DRAFT
Environmental Impact Statement

Appendix 17B

Supplemental PCN Information

The Belleayre Resort at Catskill Park

Figure 18

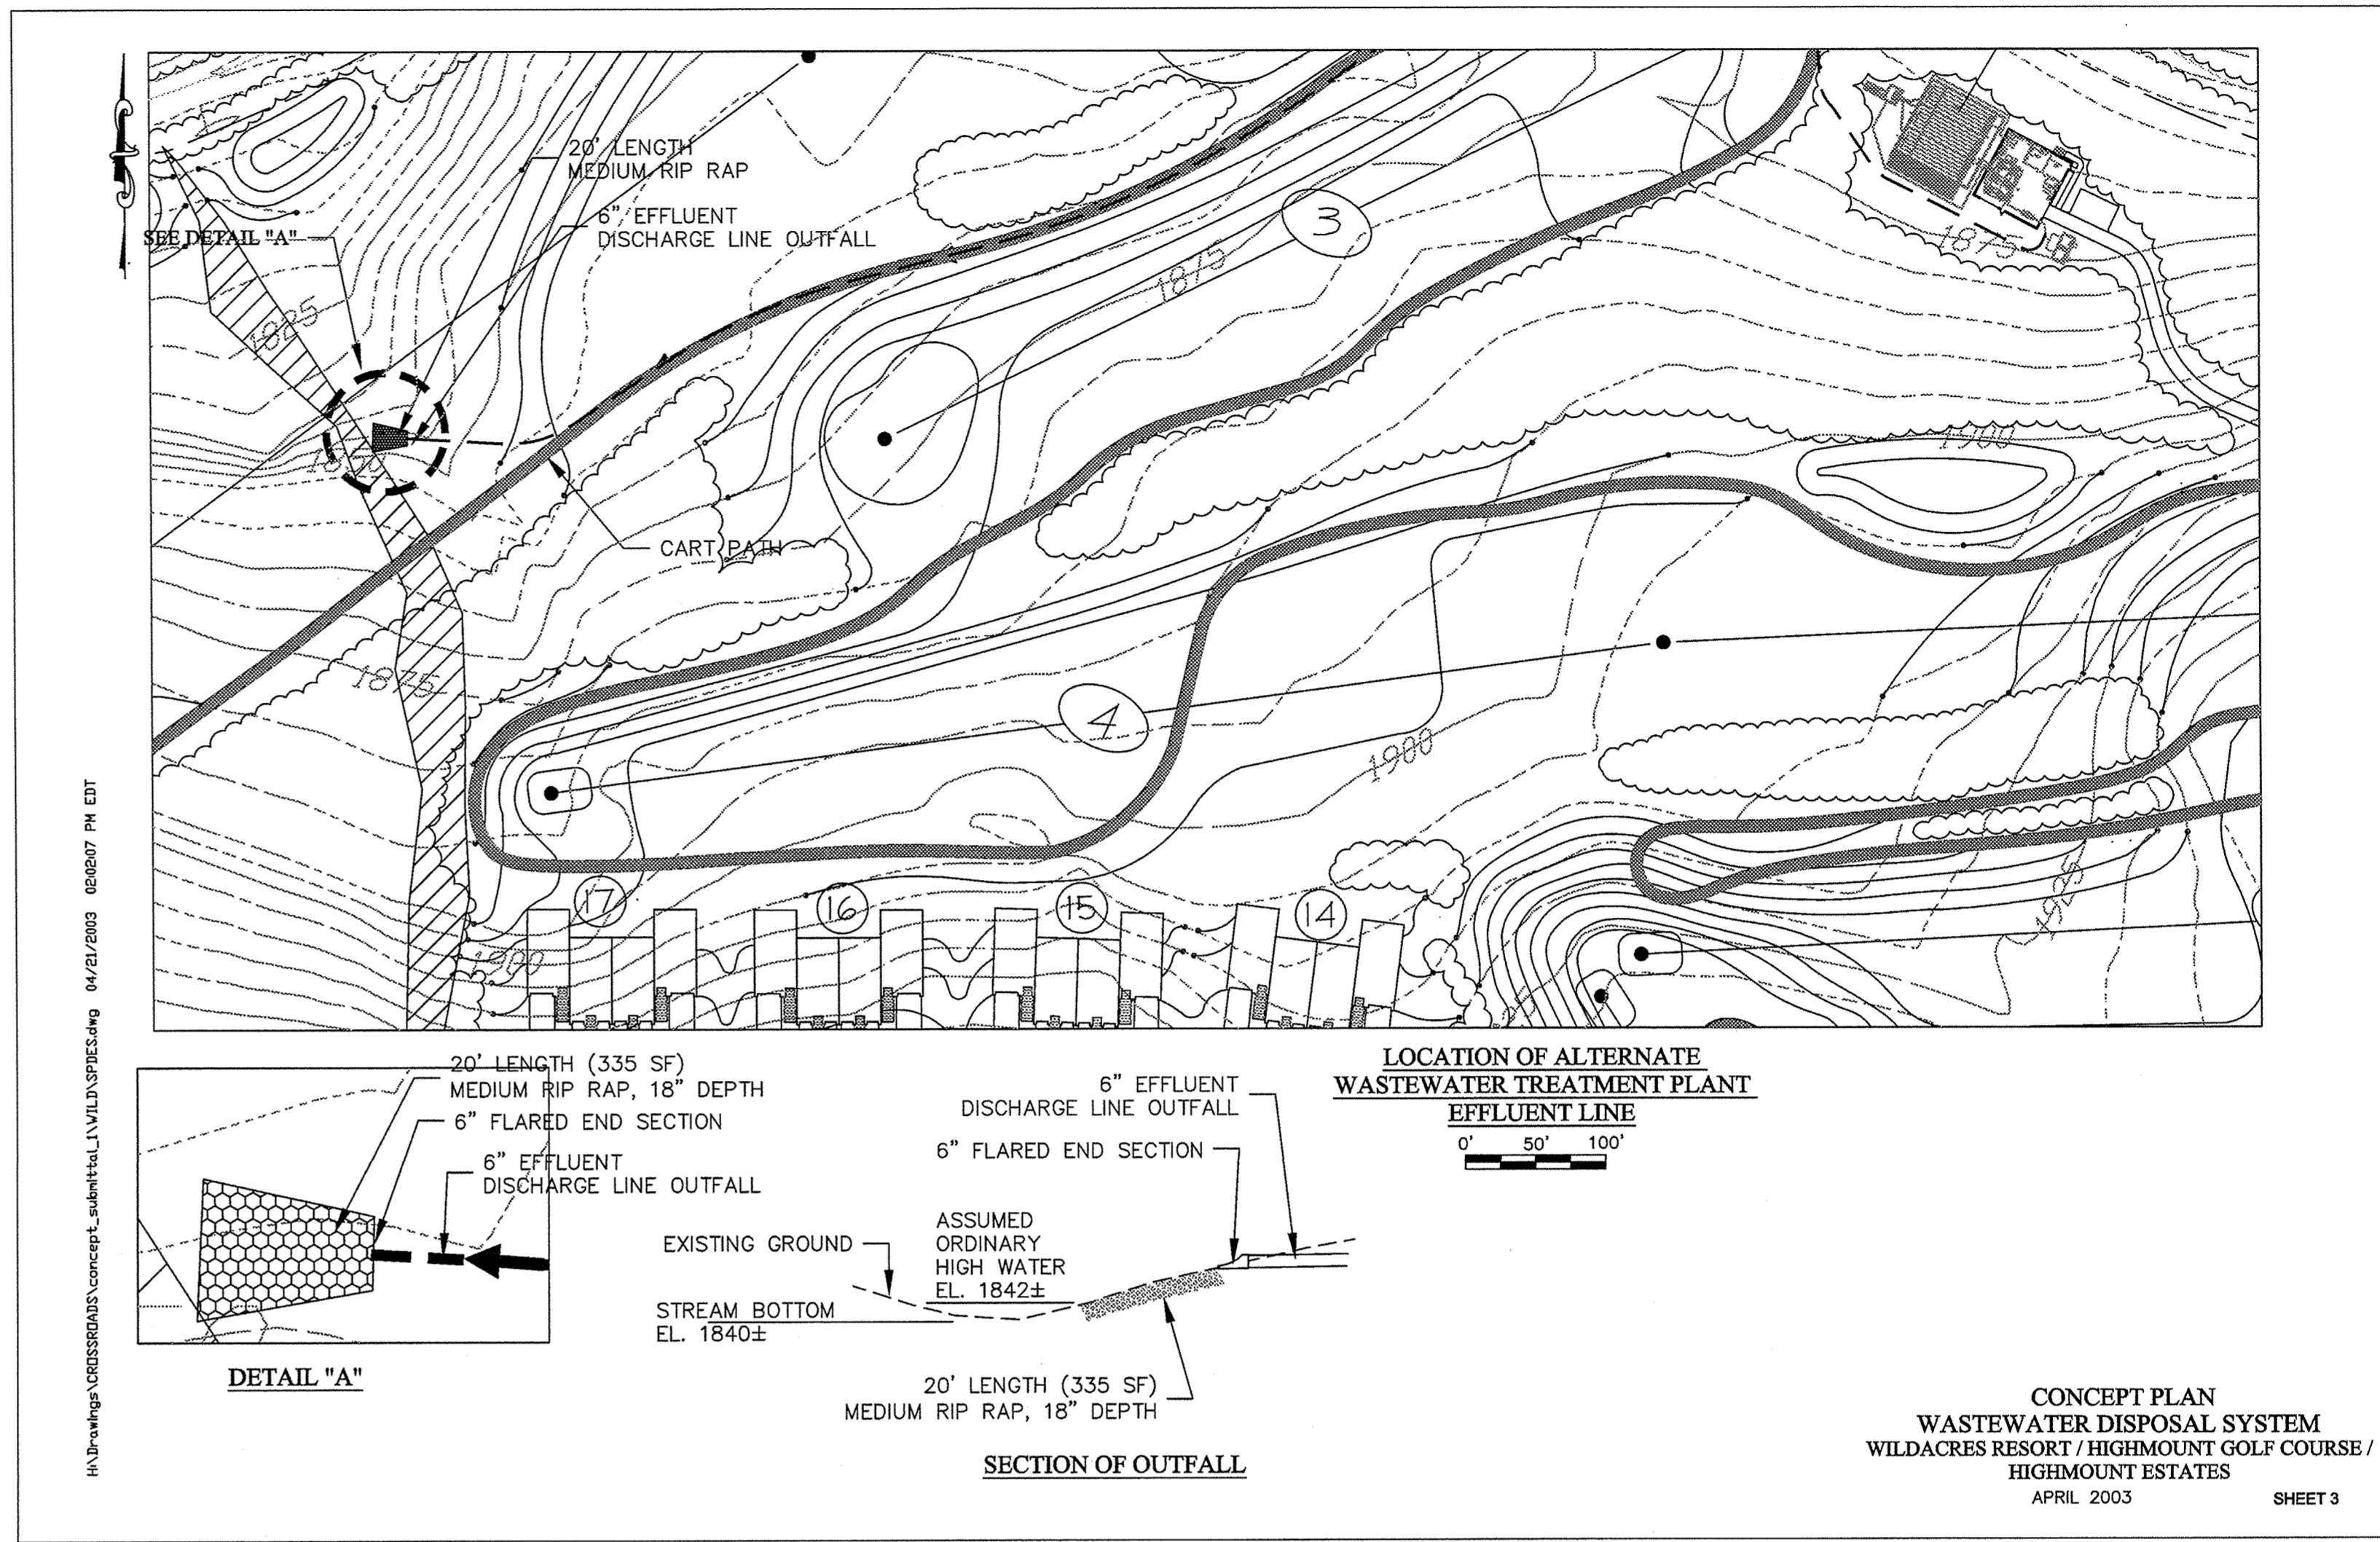
Since we last submitted information to you a new surface outfall option has been designed for the wastewater treatment plant at Wildacres (See Sheet MP-1 and Figure 18 on Detail Sheet D-3). Like the Big Indian Plateau wastewater treatment plant outfall, all activities for the Wildacres wastewater treatment plant outfall are proposed above the ordinary high water mark and outside of the wetlands. There are no wetlands between the treatment plant and the outfall location that would require utility line crossings.
